# WALDEN PRESERVE 2

## Filing No. 4

### Grading & Erosion Control Plans

#### El Paso County, Colorado

**TITLE SHEET**

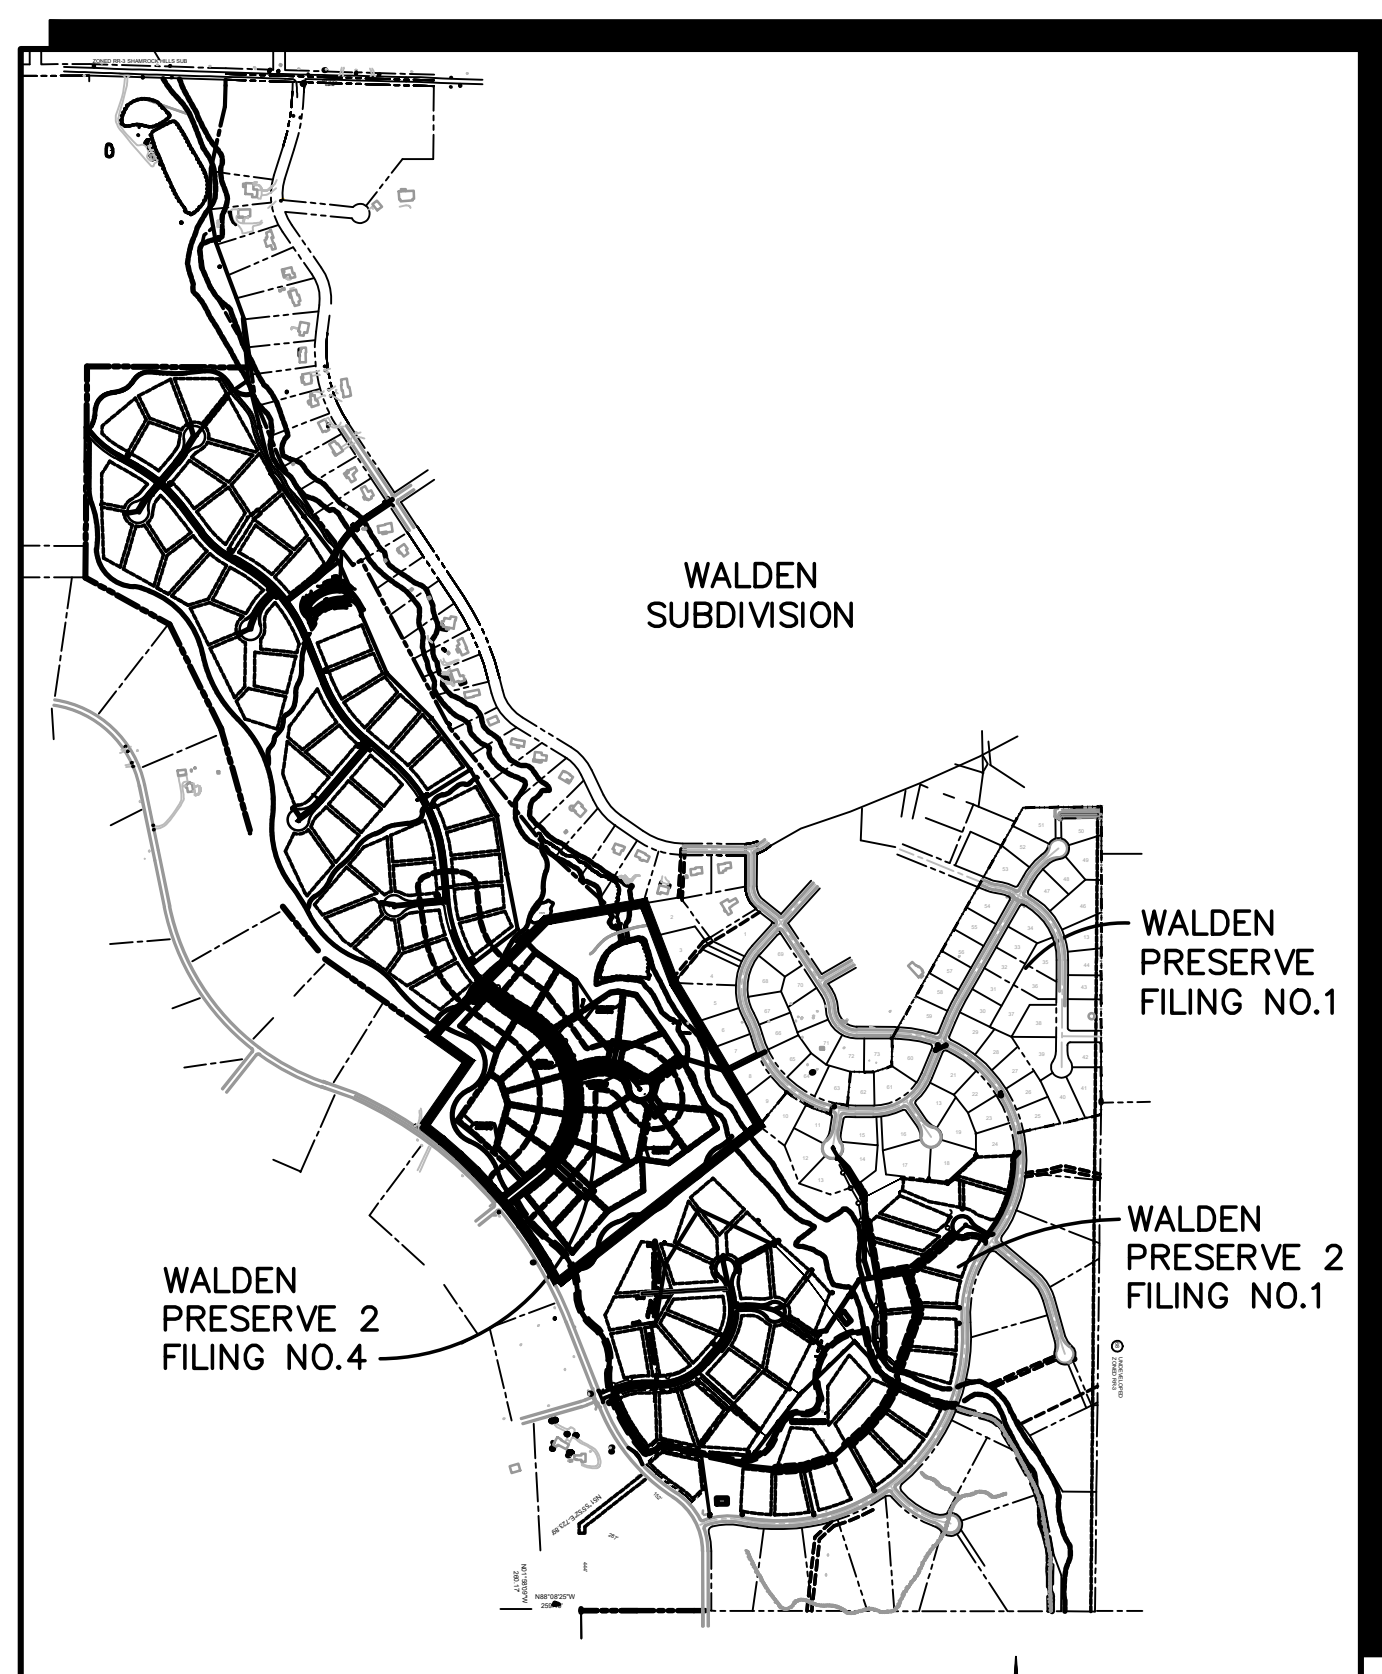
Replace the 3rd paragraph with:  
In accordance with ECM Section 1.12, these construction documents will be valid for construction for a period of 2 years from the date signed by the El Paso County Engineer. If construction has not started within those 2 years, the plans will need to be resubmitted for approval, including payment of review fees at the Planning and Community Development Directors discretion

Add "PCD File No. SF-18-034"

## OVERALL SITE PLAN

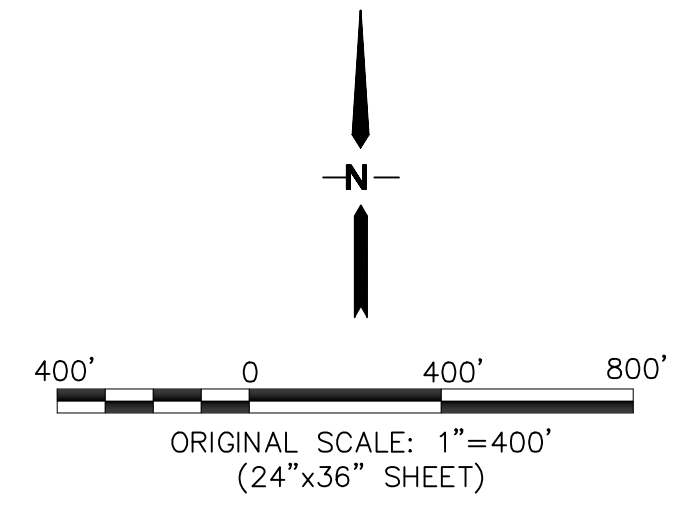
The drainage map called for a 36" culvert across lots 8,9,10

**SITE GRADING & EROSION CONTROL PLAN**

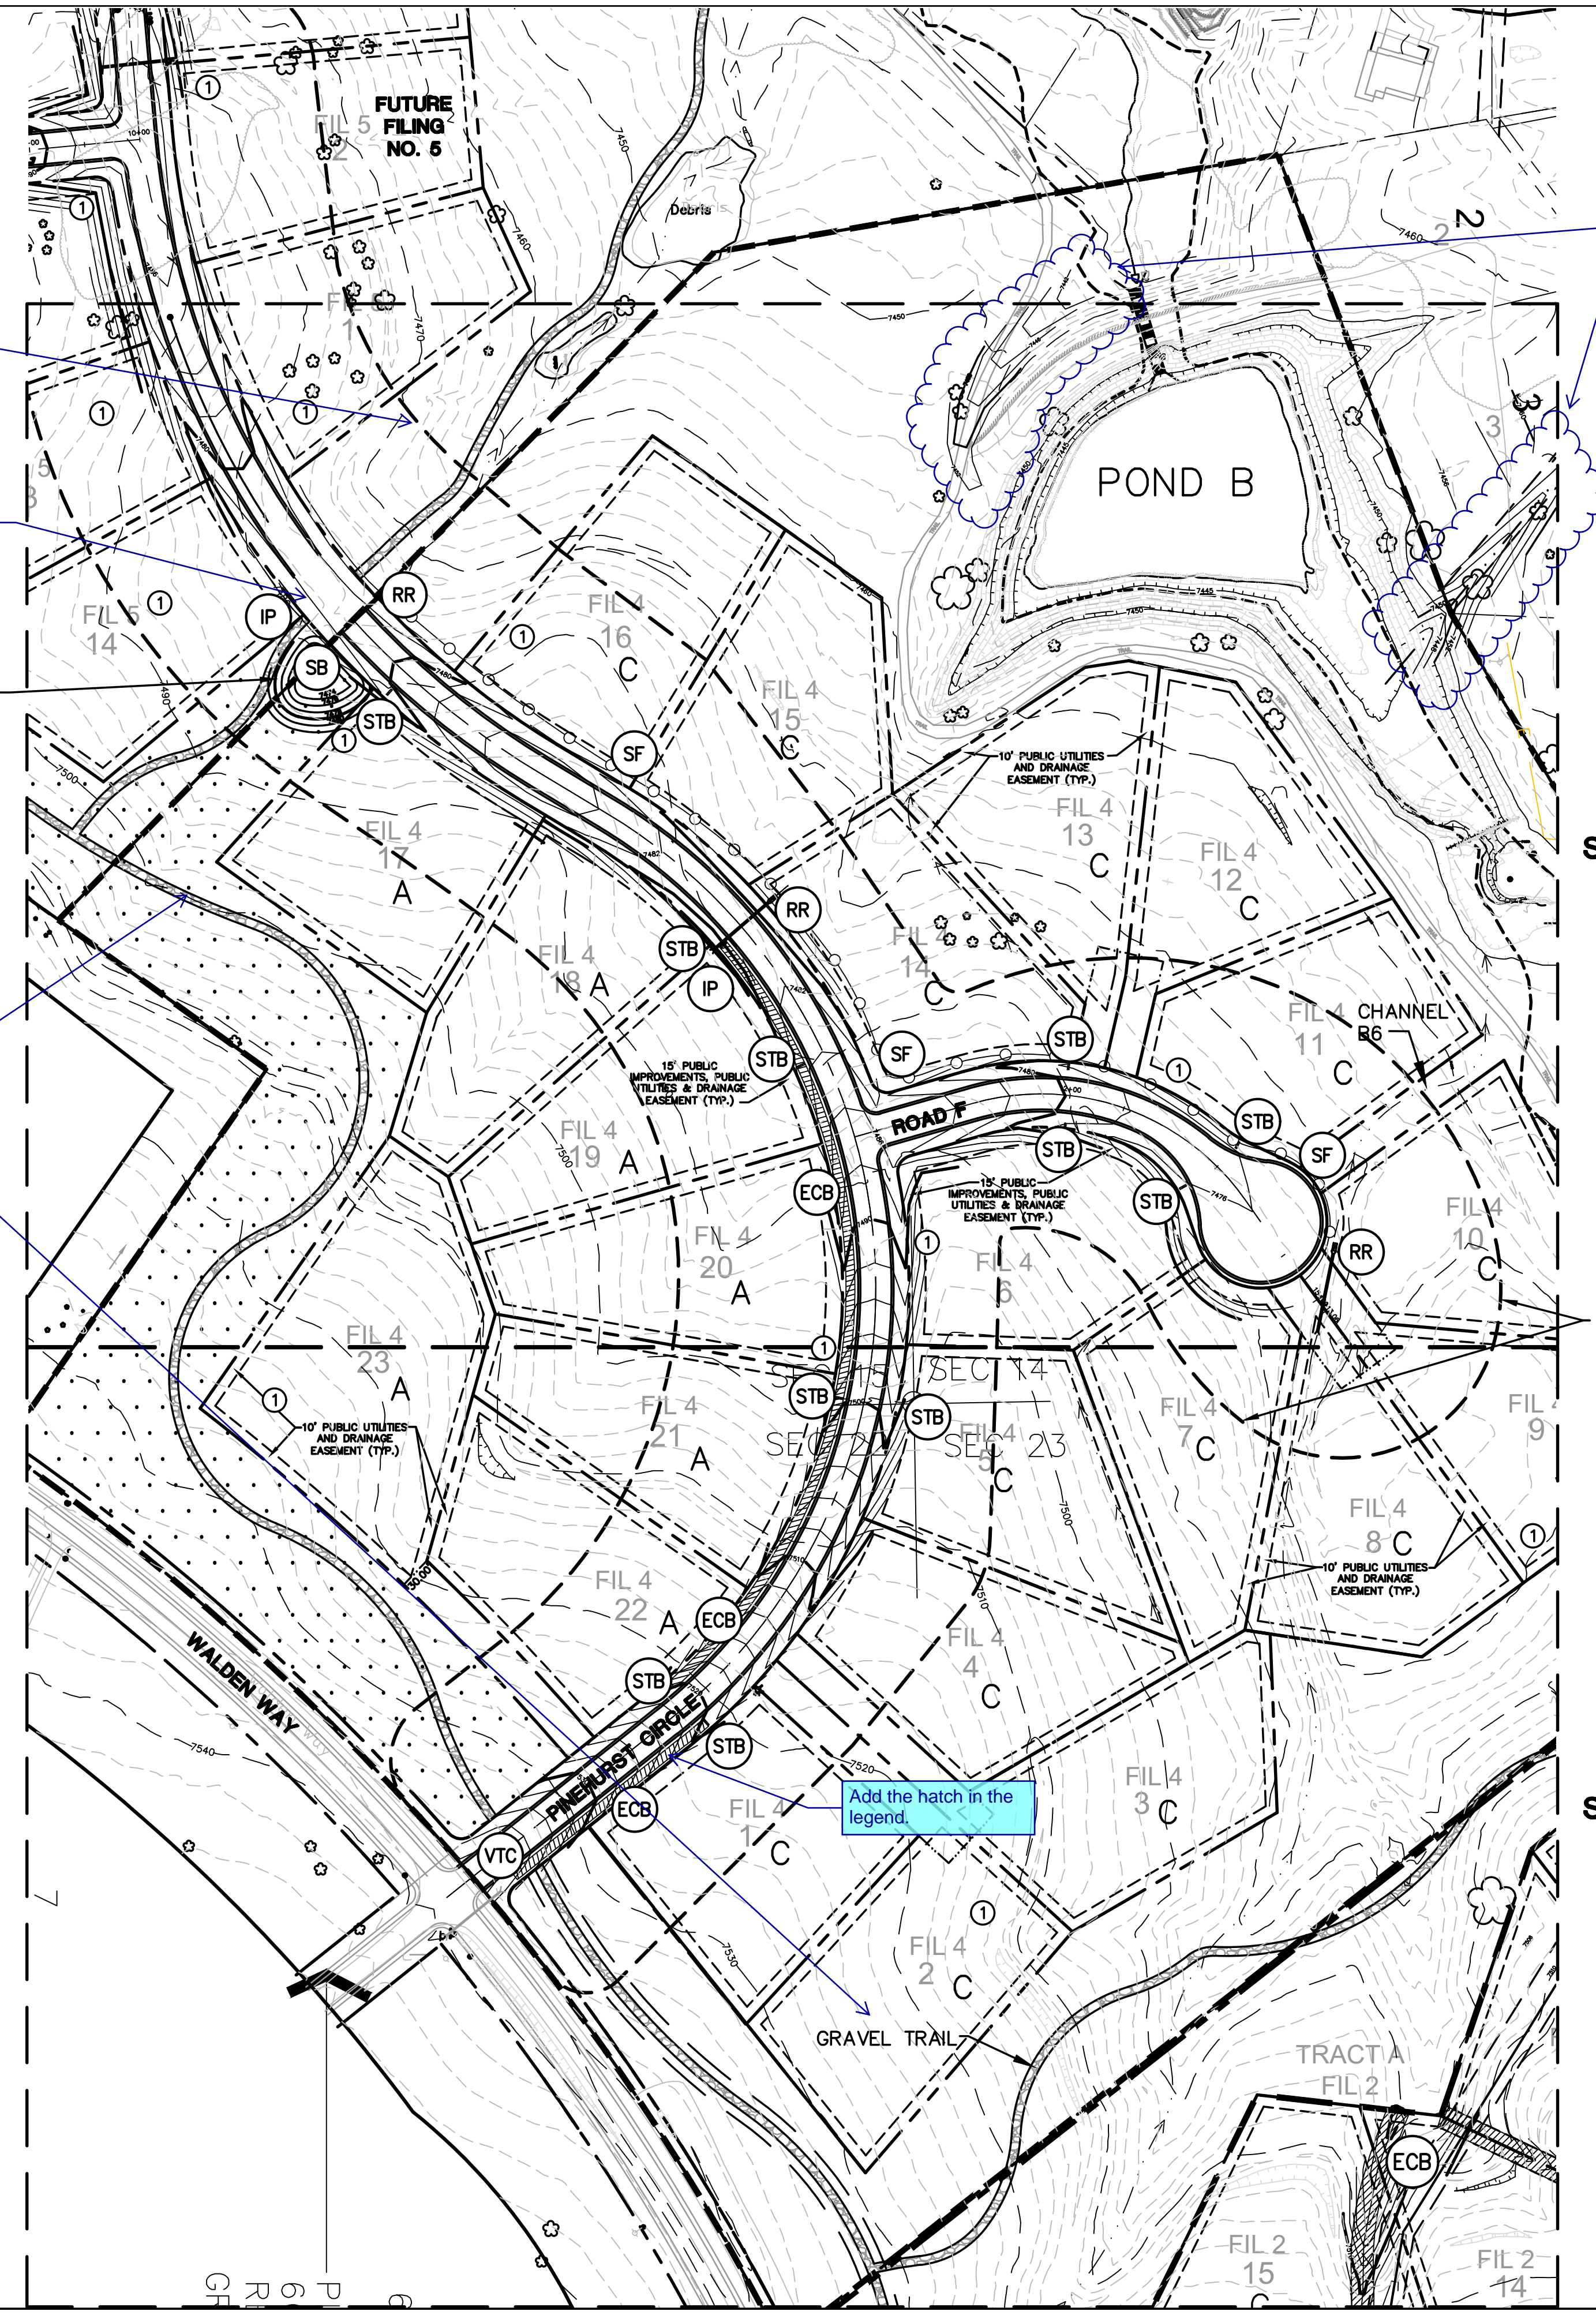
Update the limits of disturbance to encompass Filing 4 improvements only.

Provide a temporary cul-de-sac. Show the grading for the temporary cul-de-sac.

Label the trails as existing or proposed. If the trails are being constructed with filing 4 then the limits of construction/disturbed area should include the trails.

Were these part of the proposed grading with Filing 1? Identify as not a part of Filing 4.

Add the hatch in the legend.
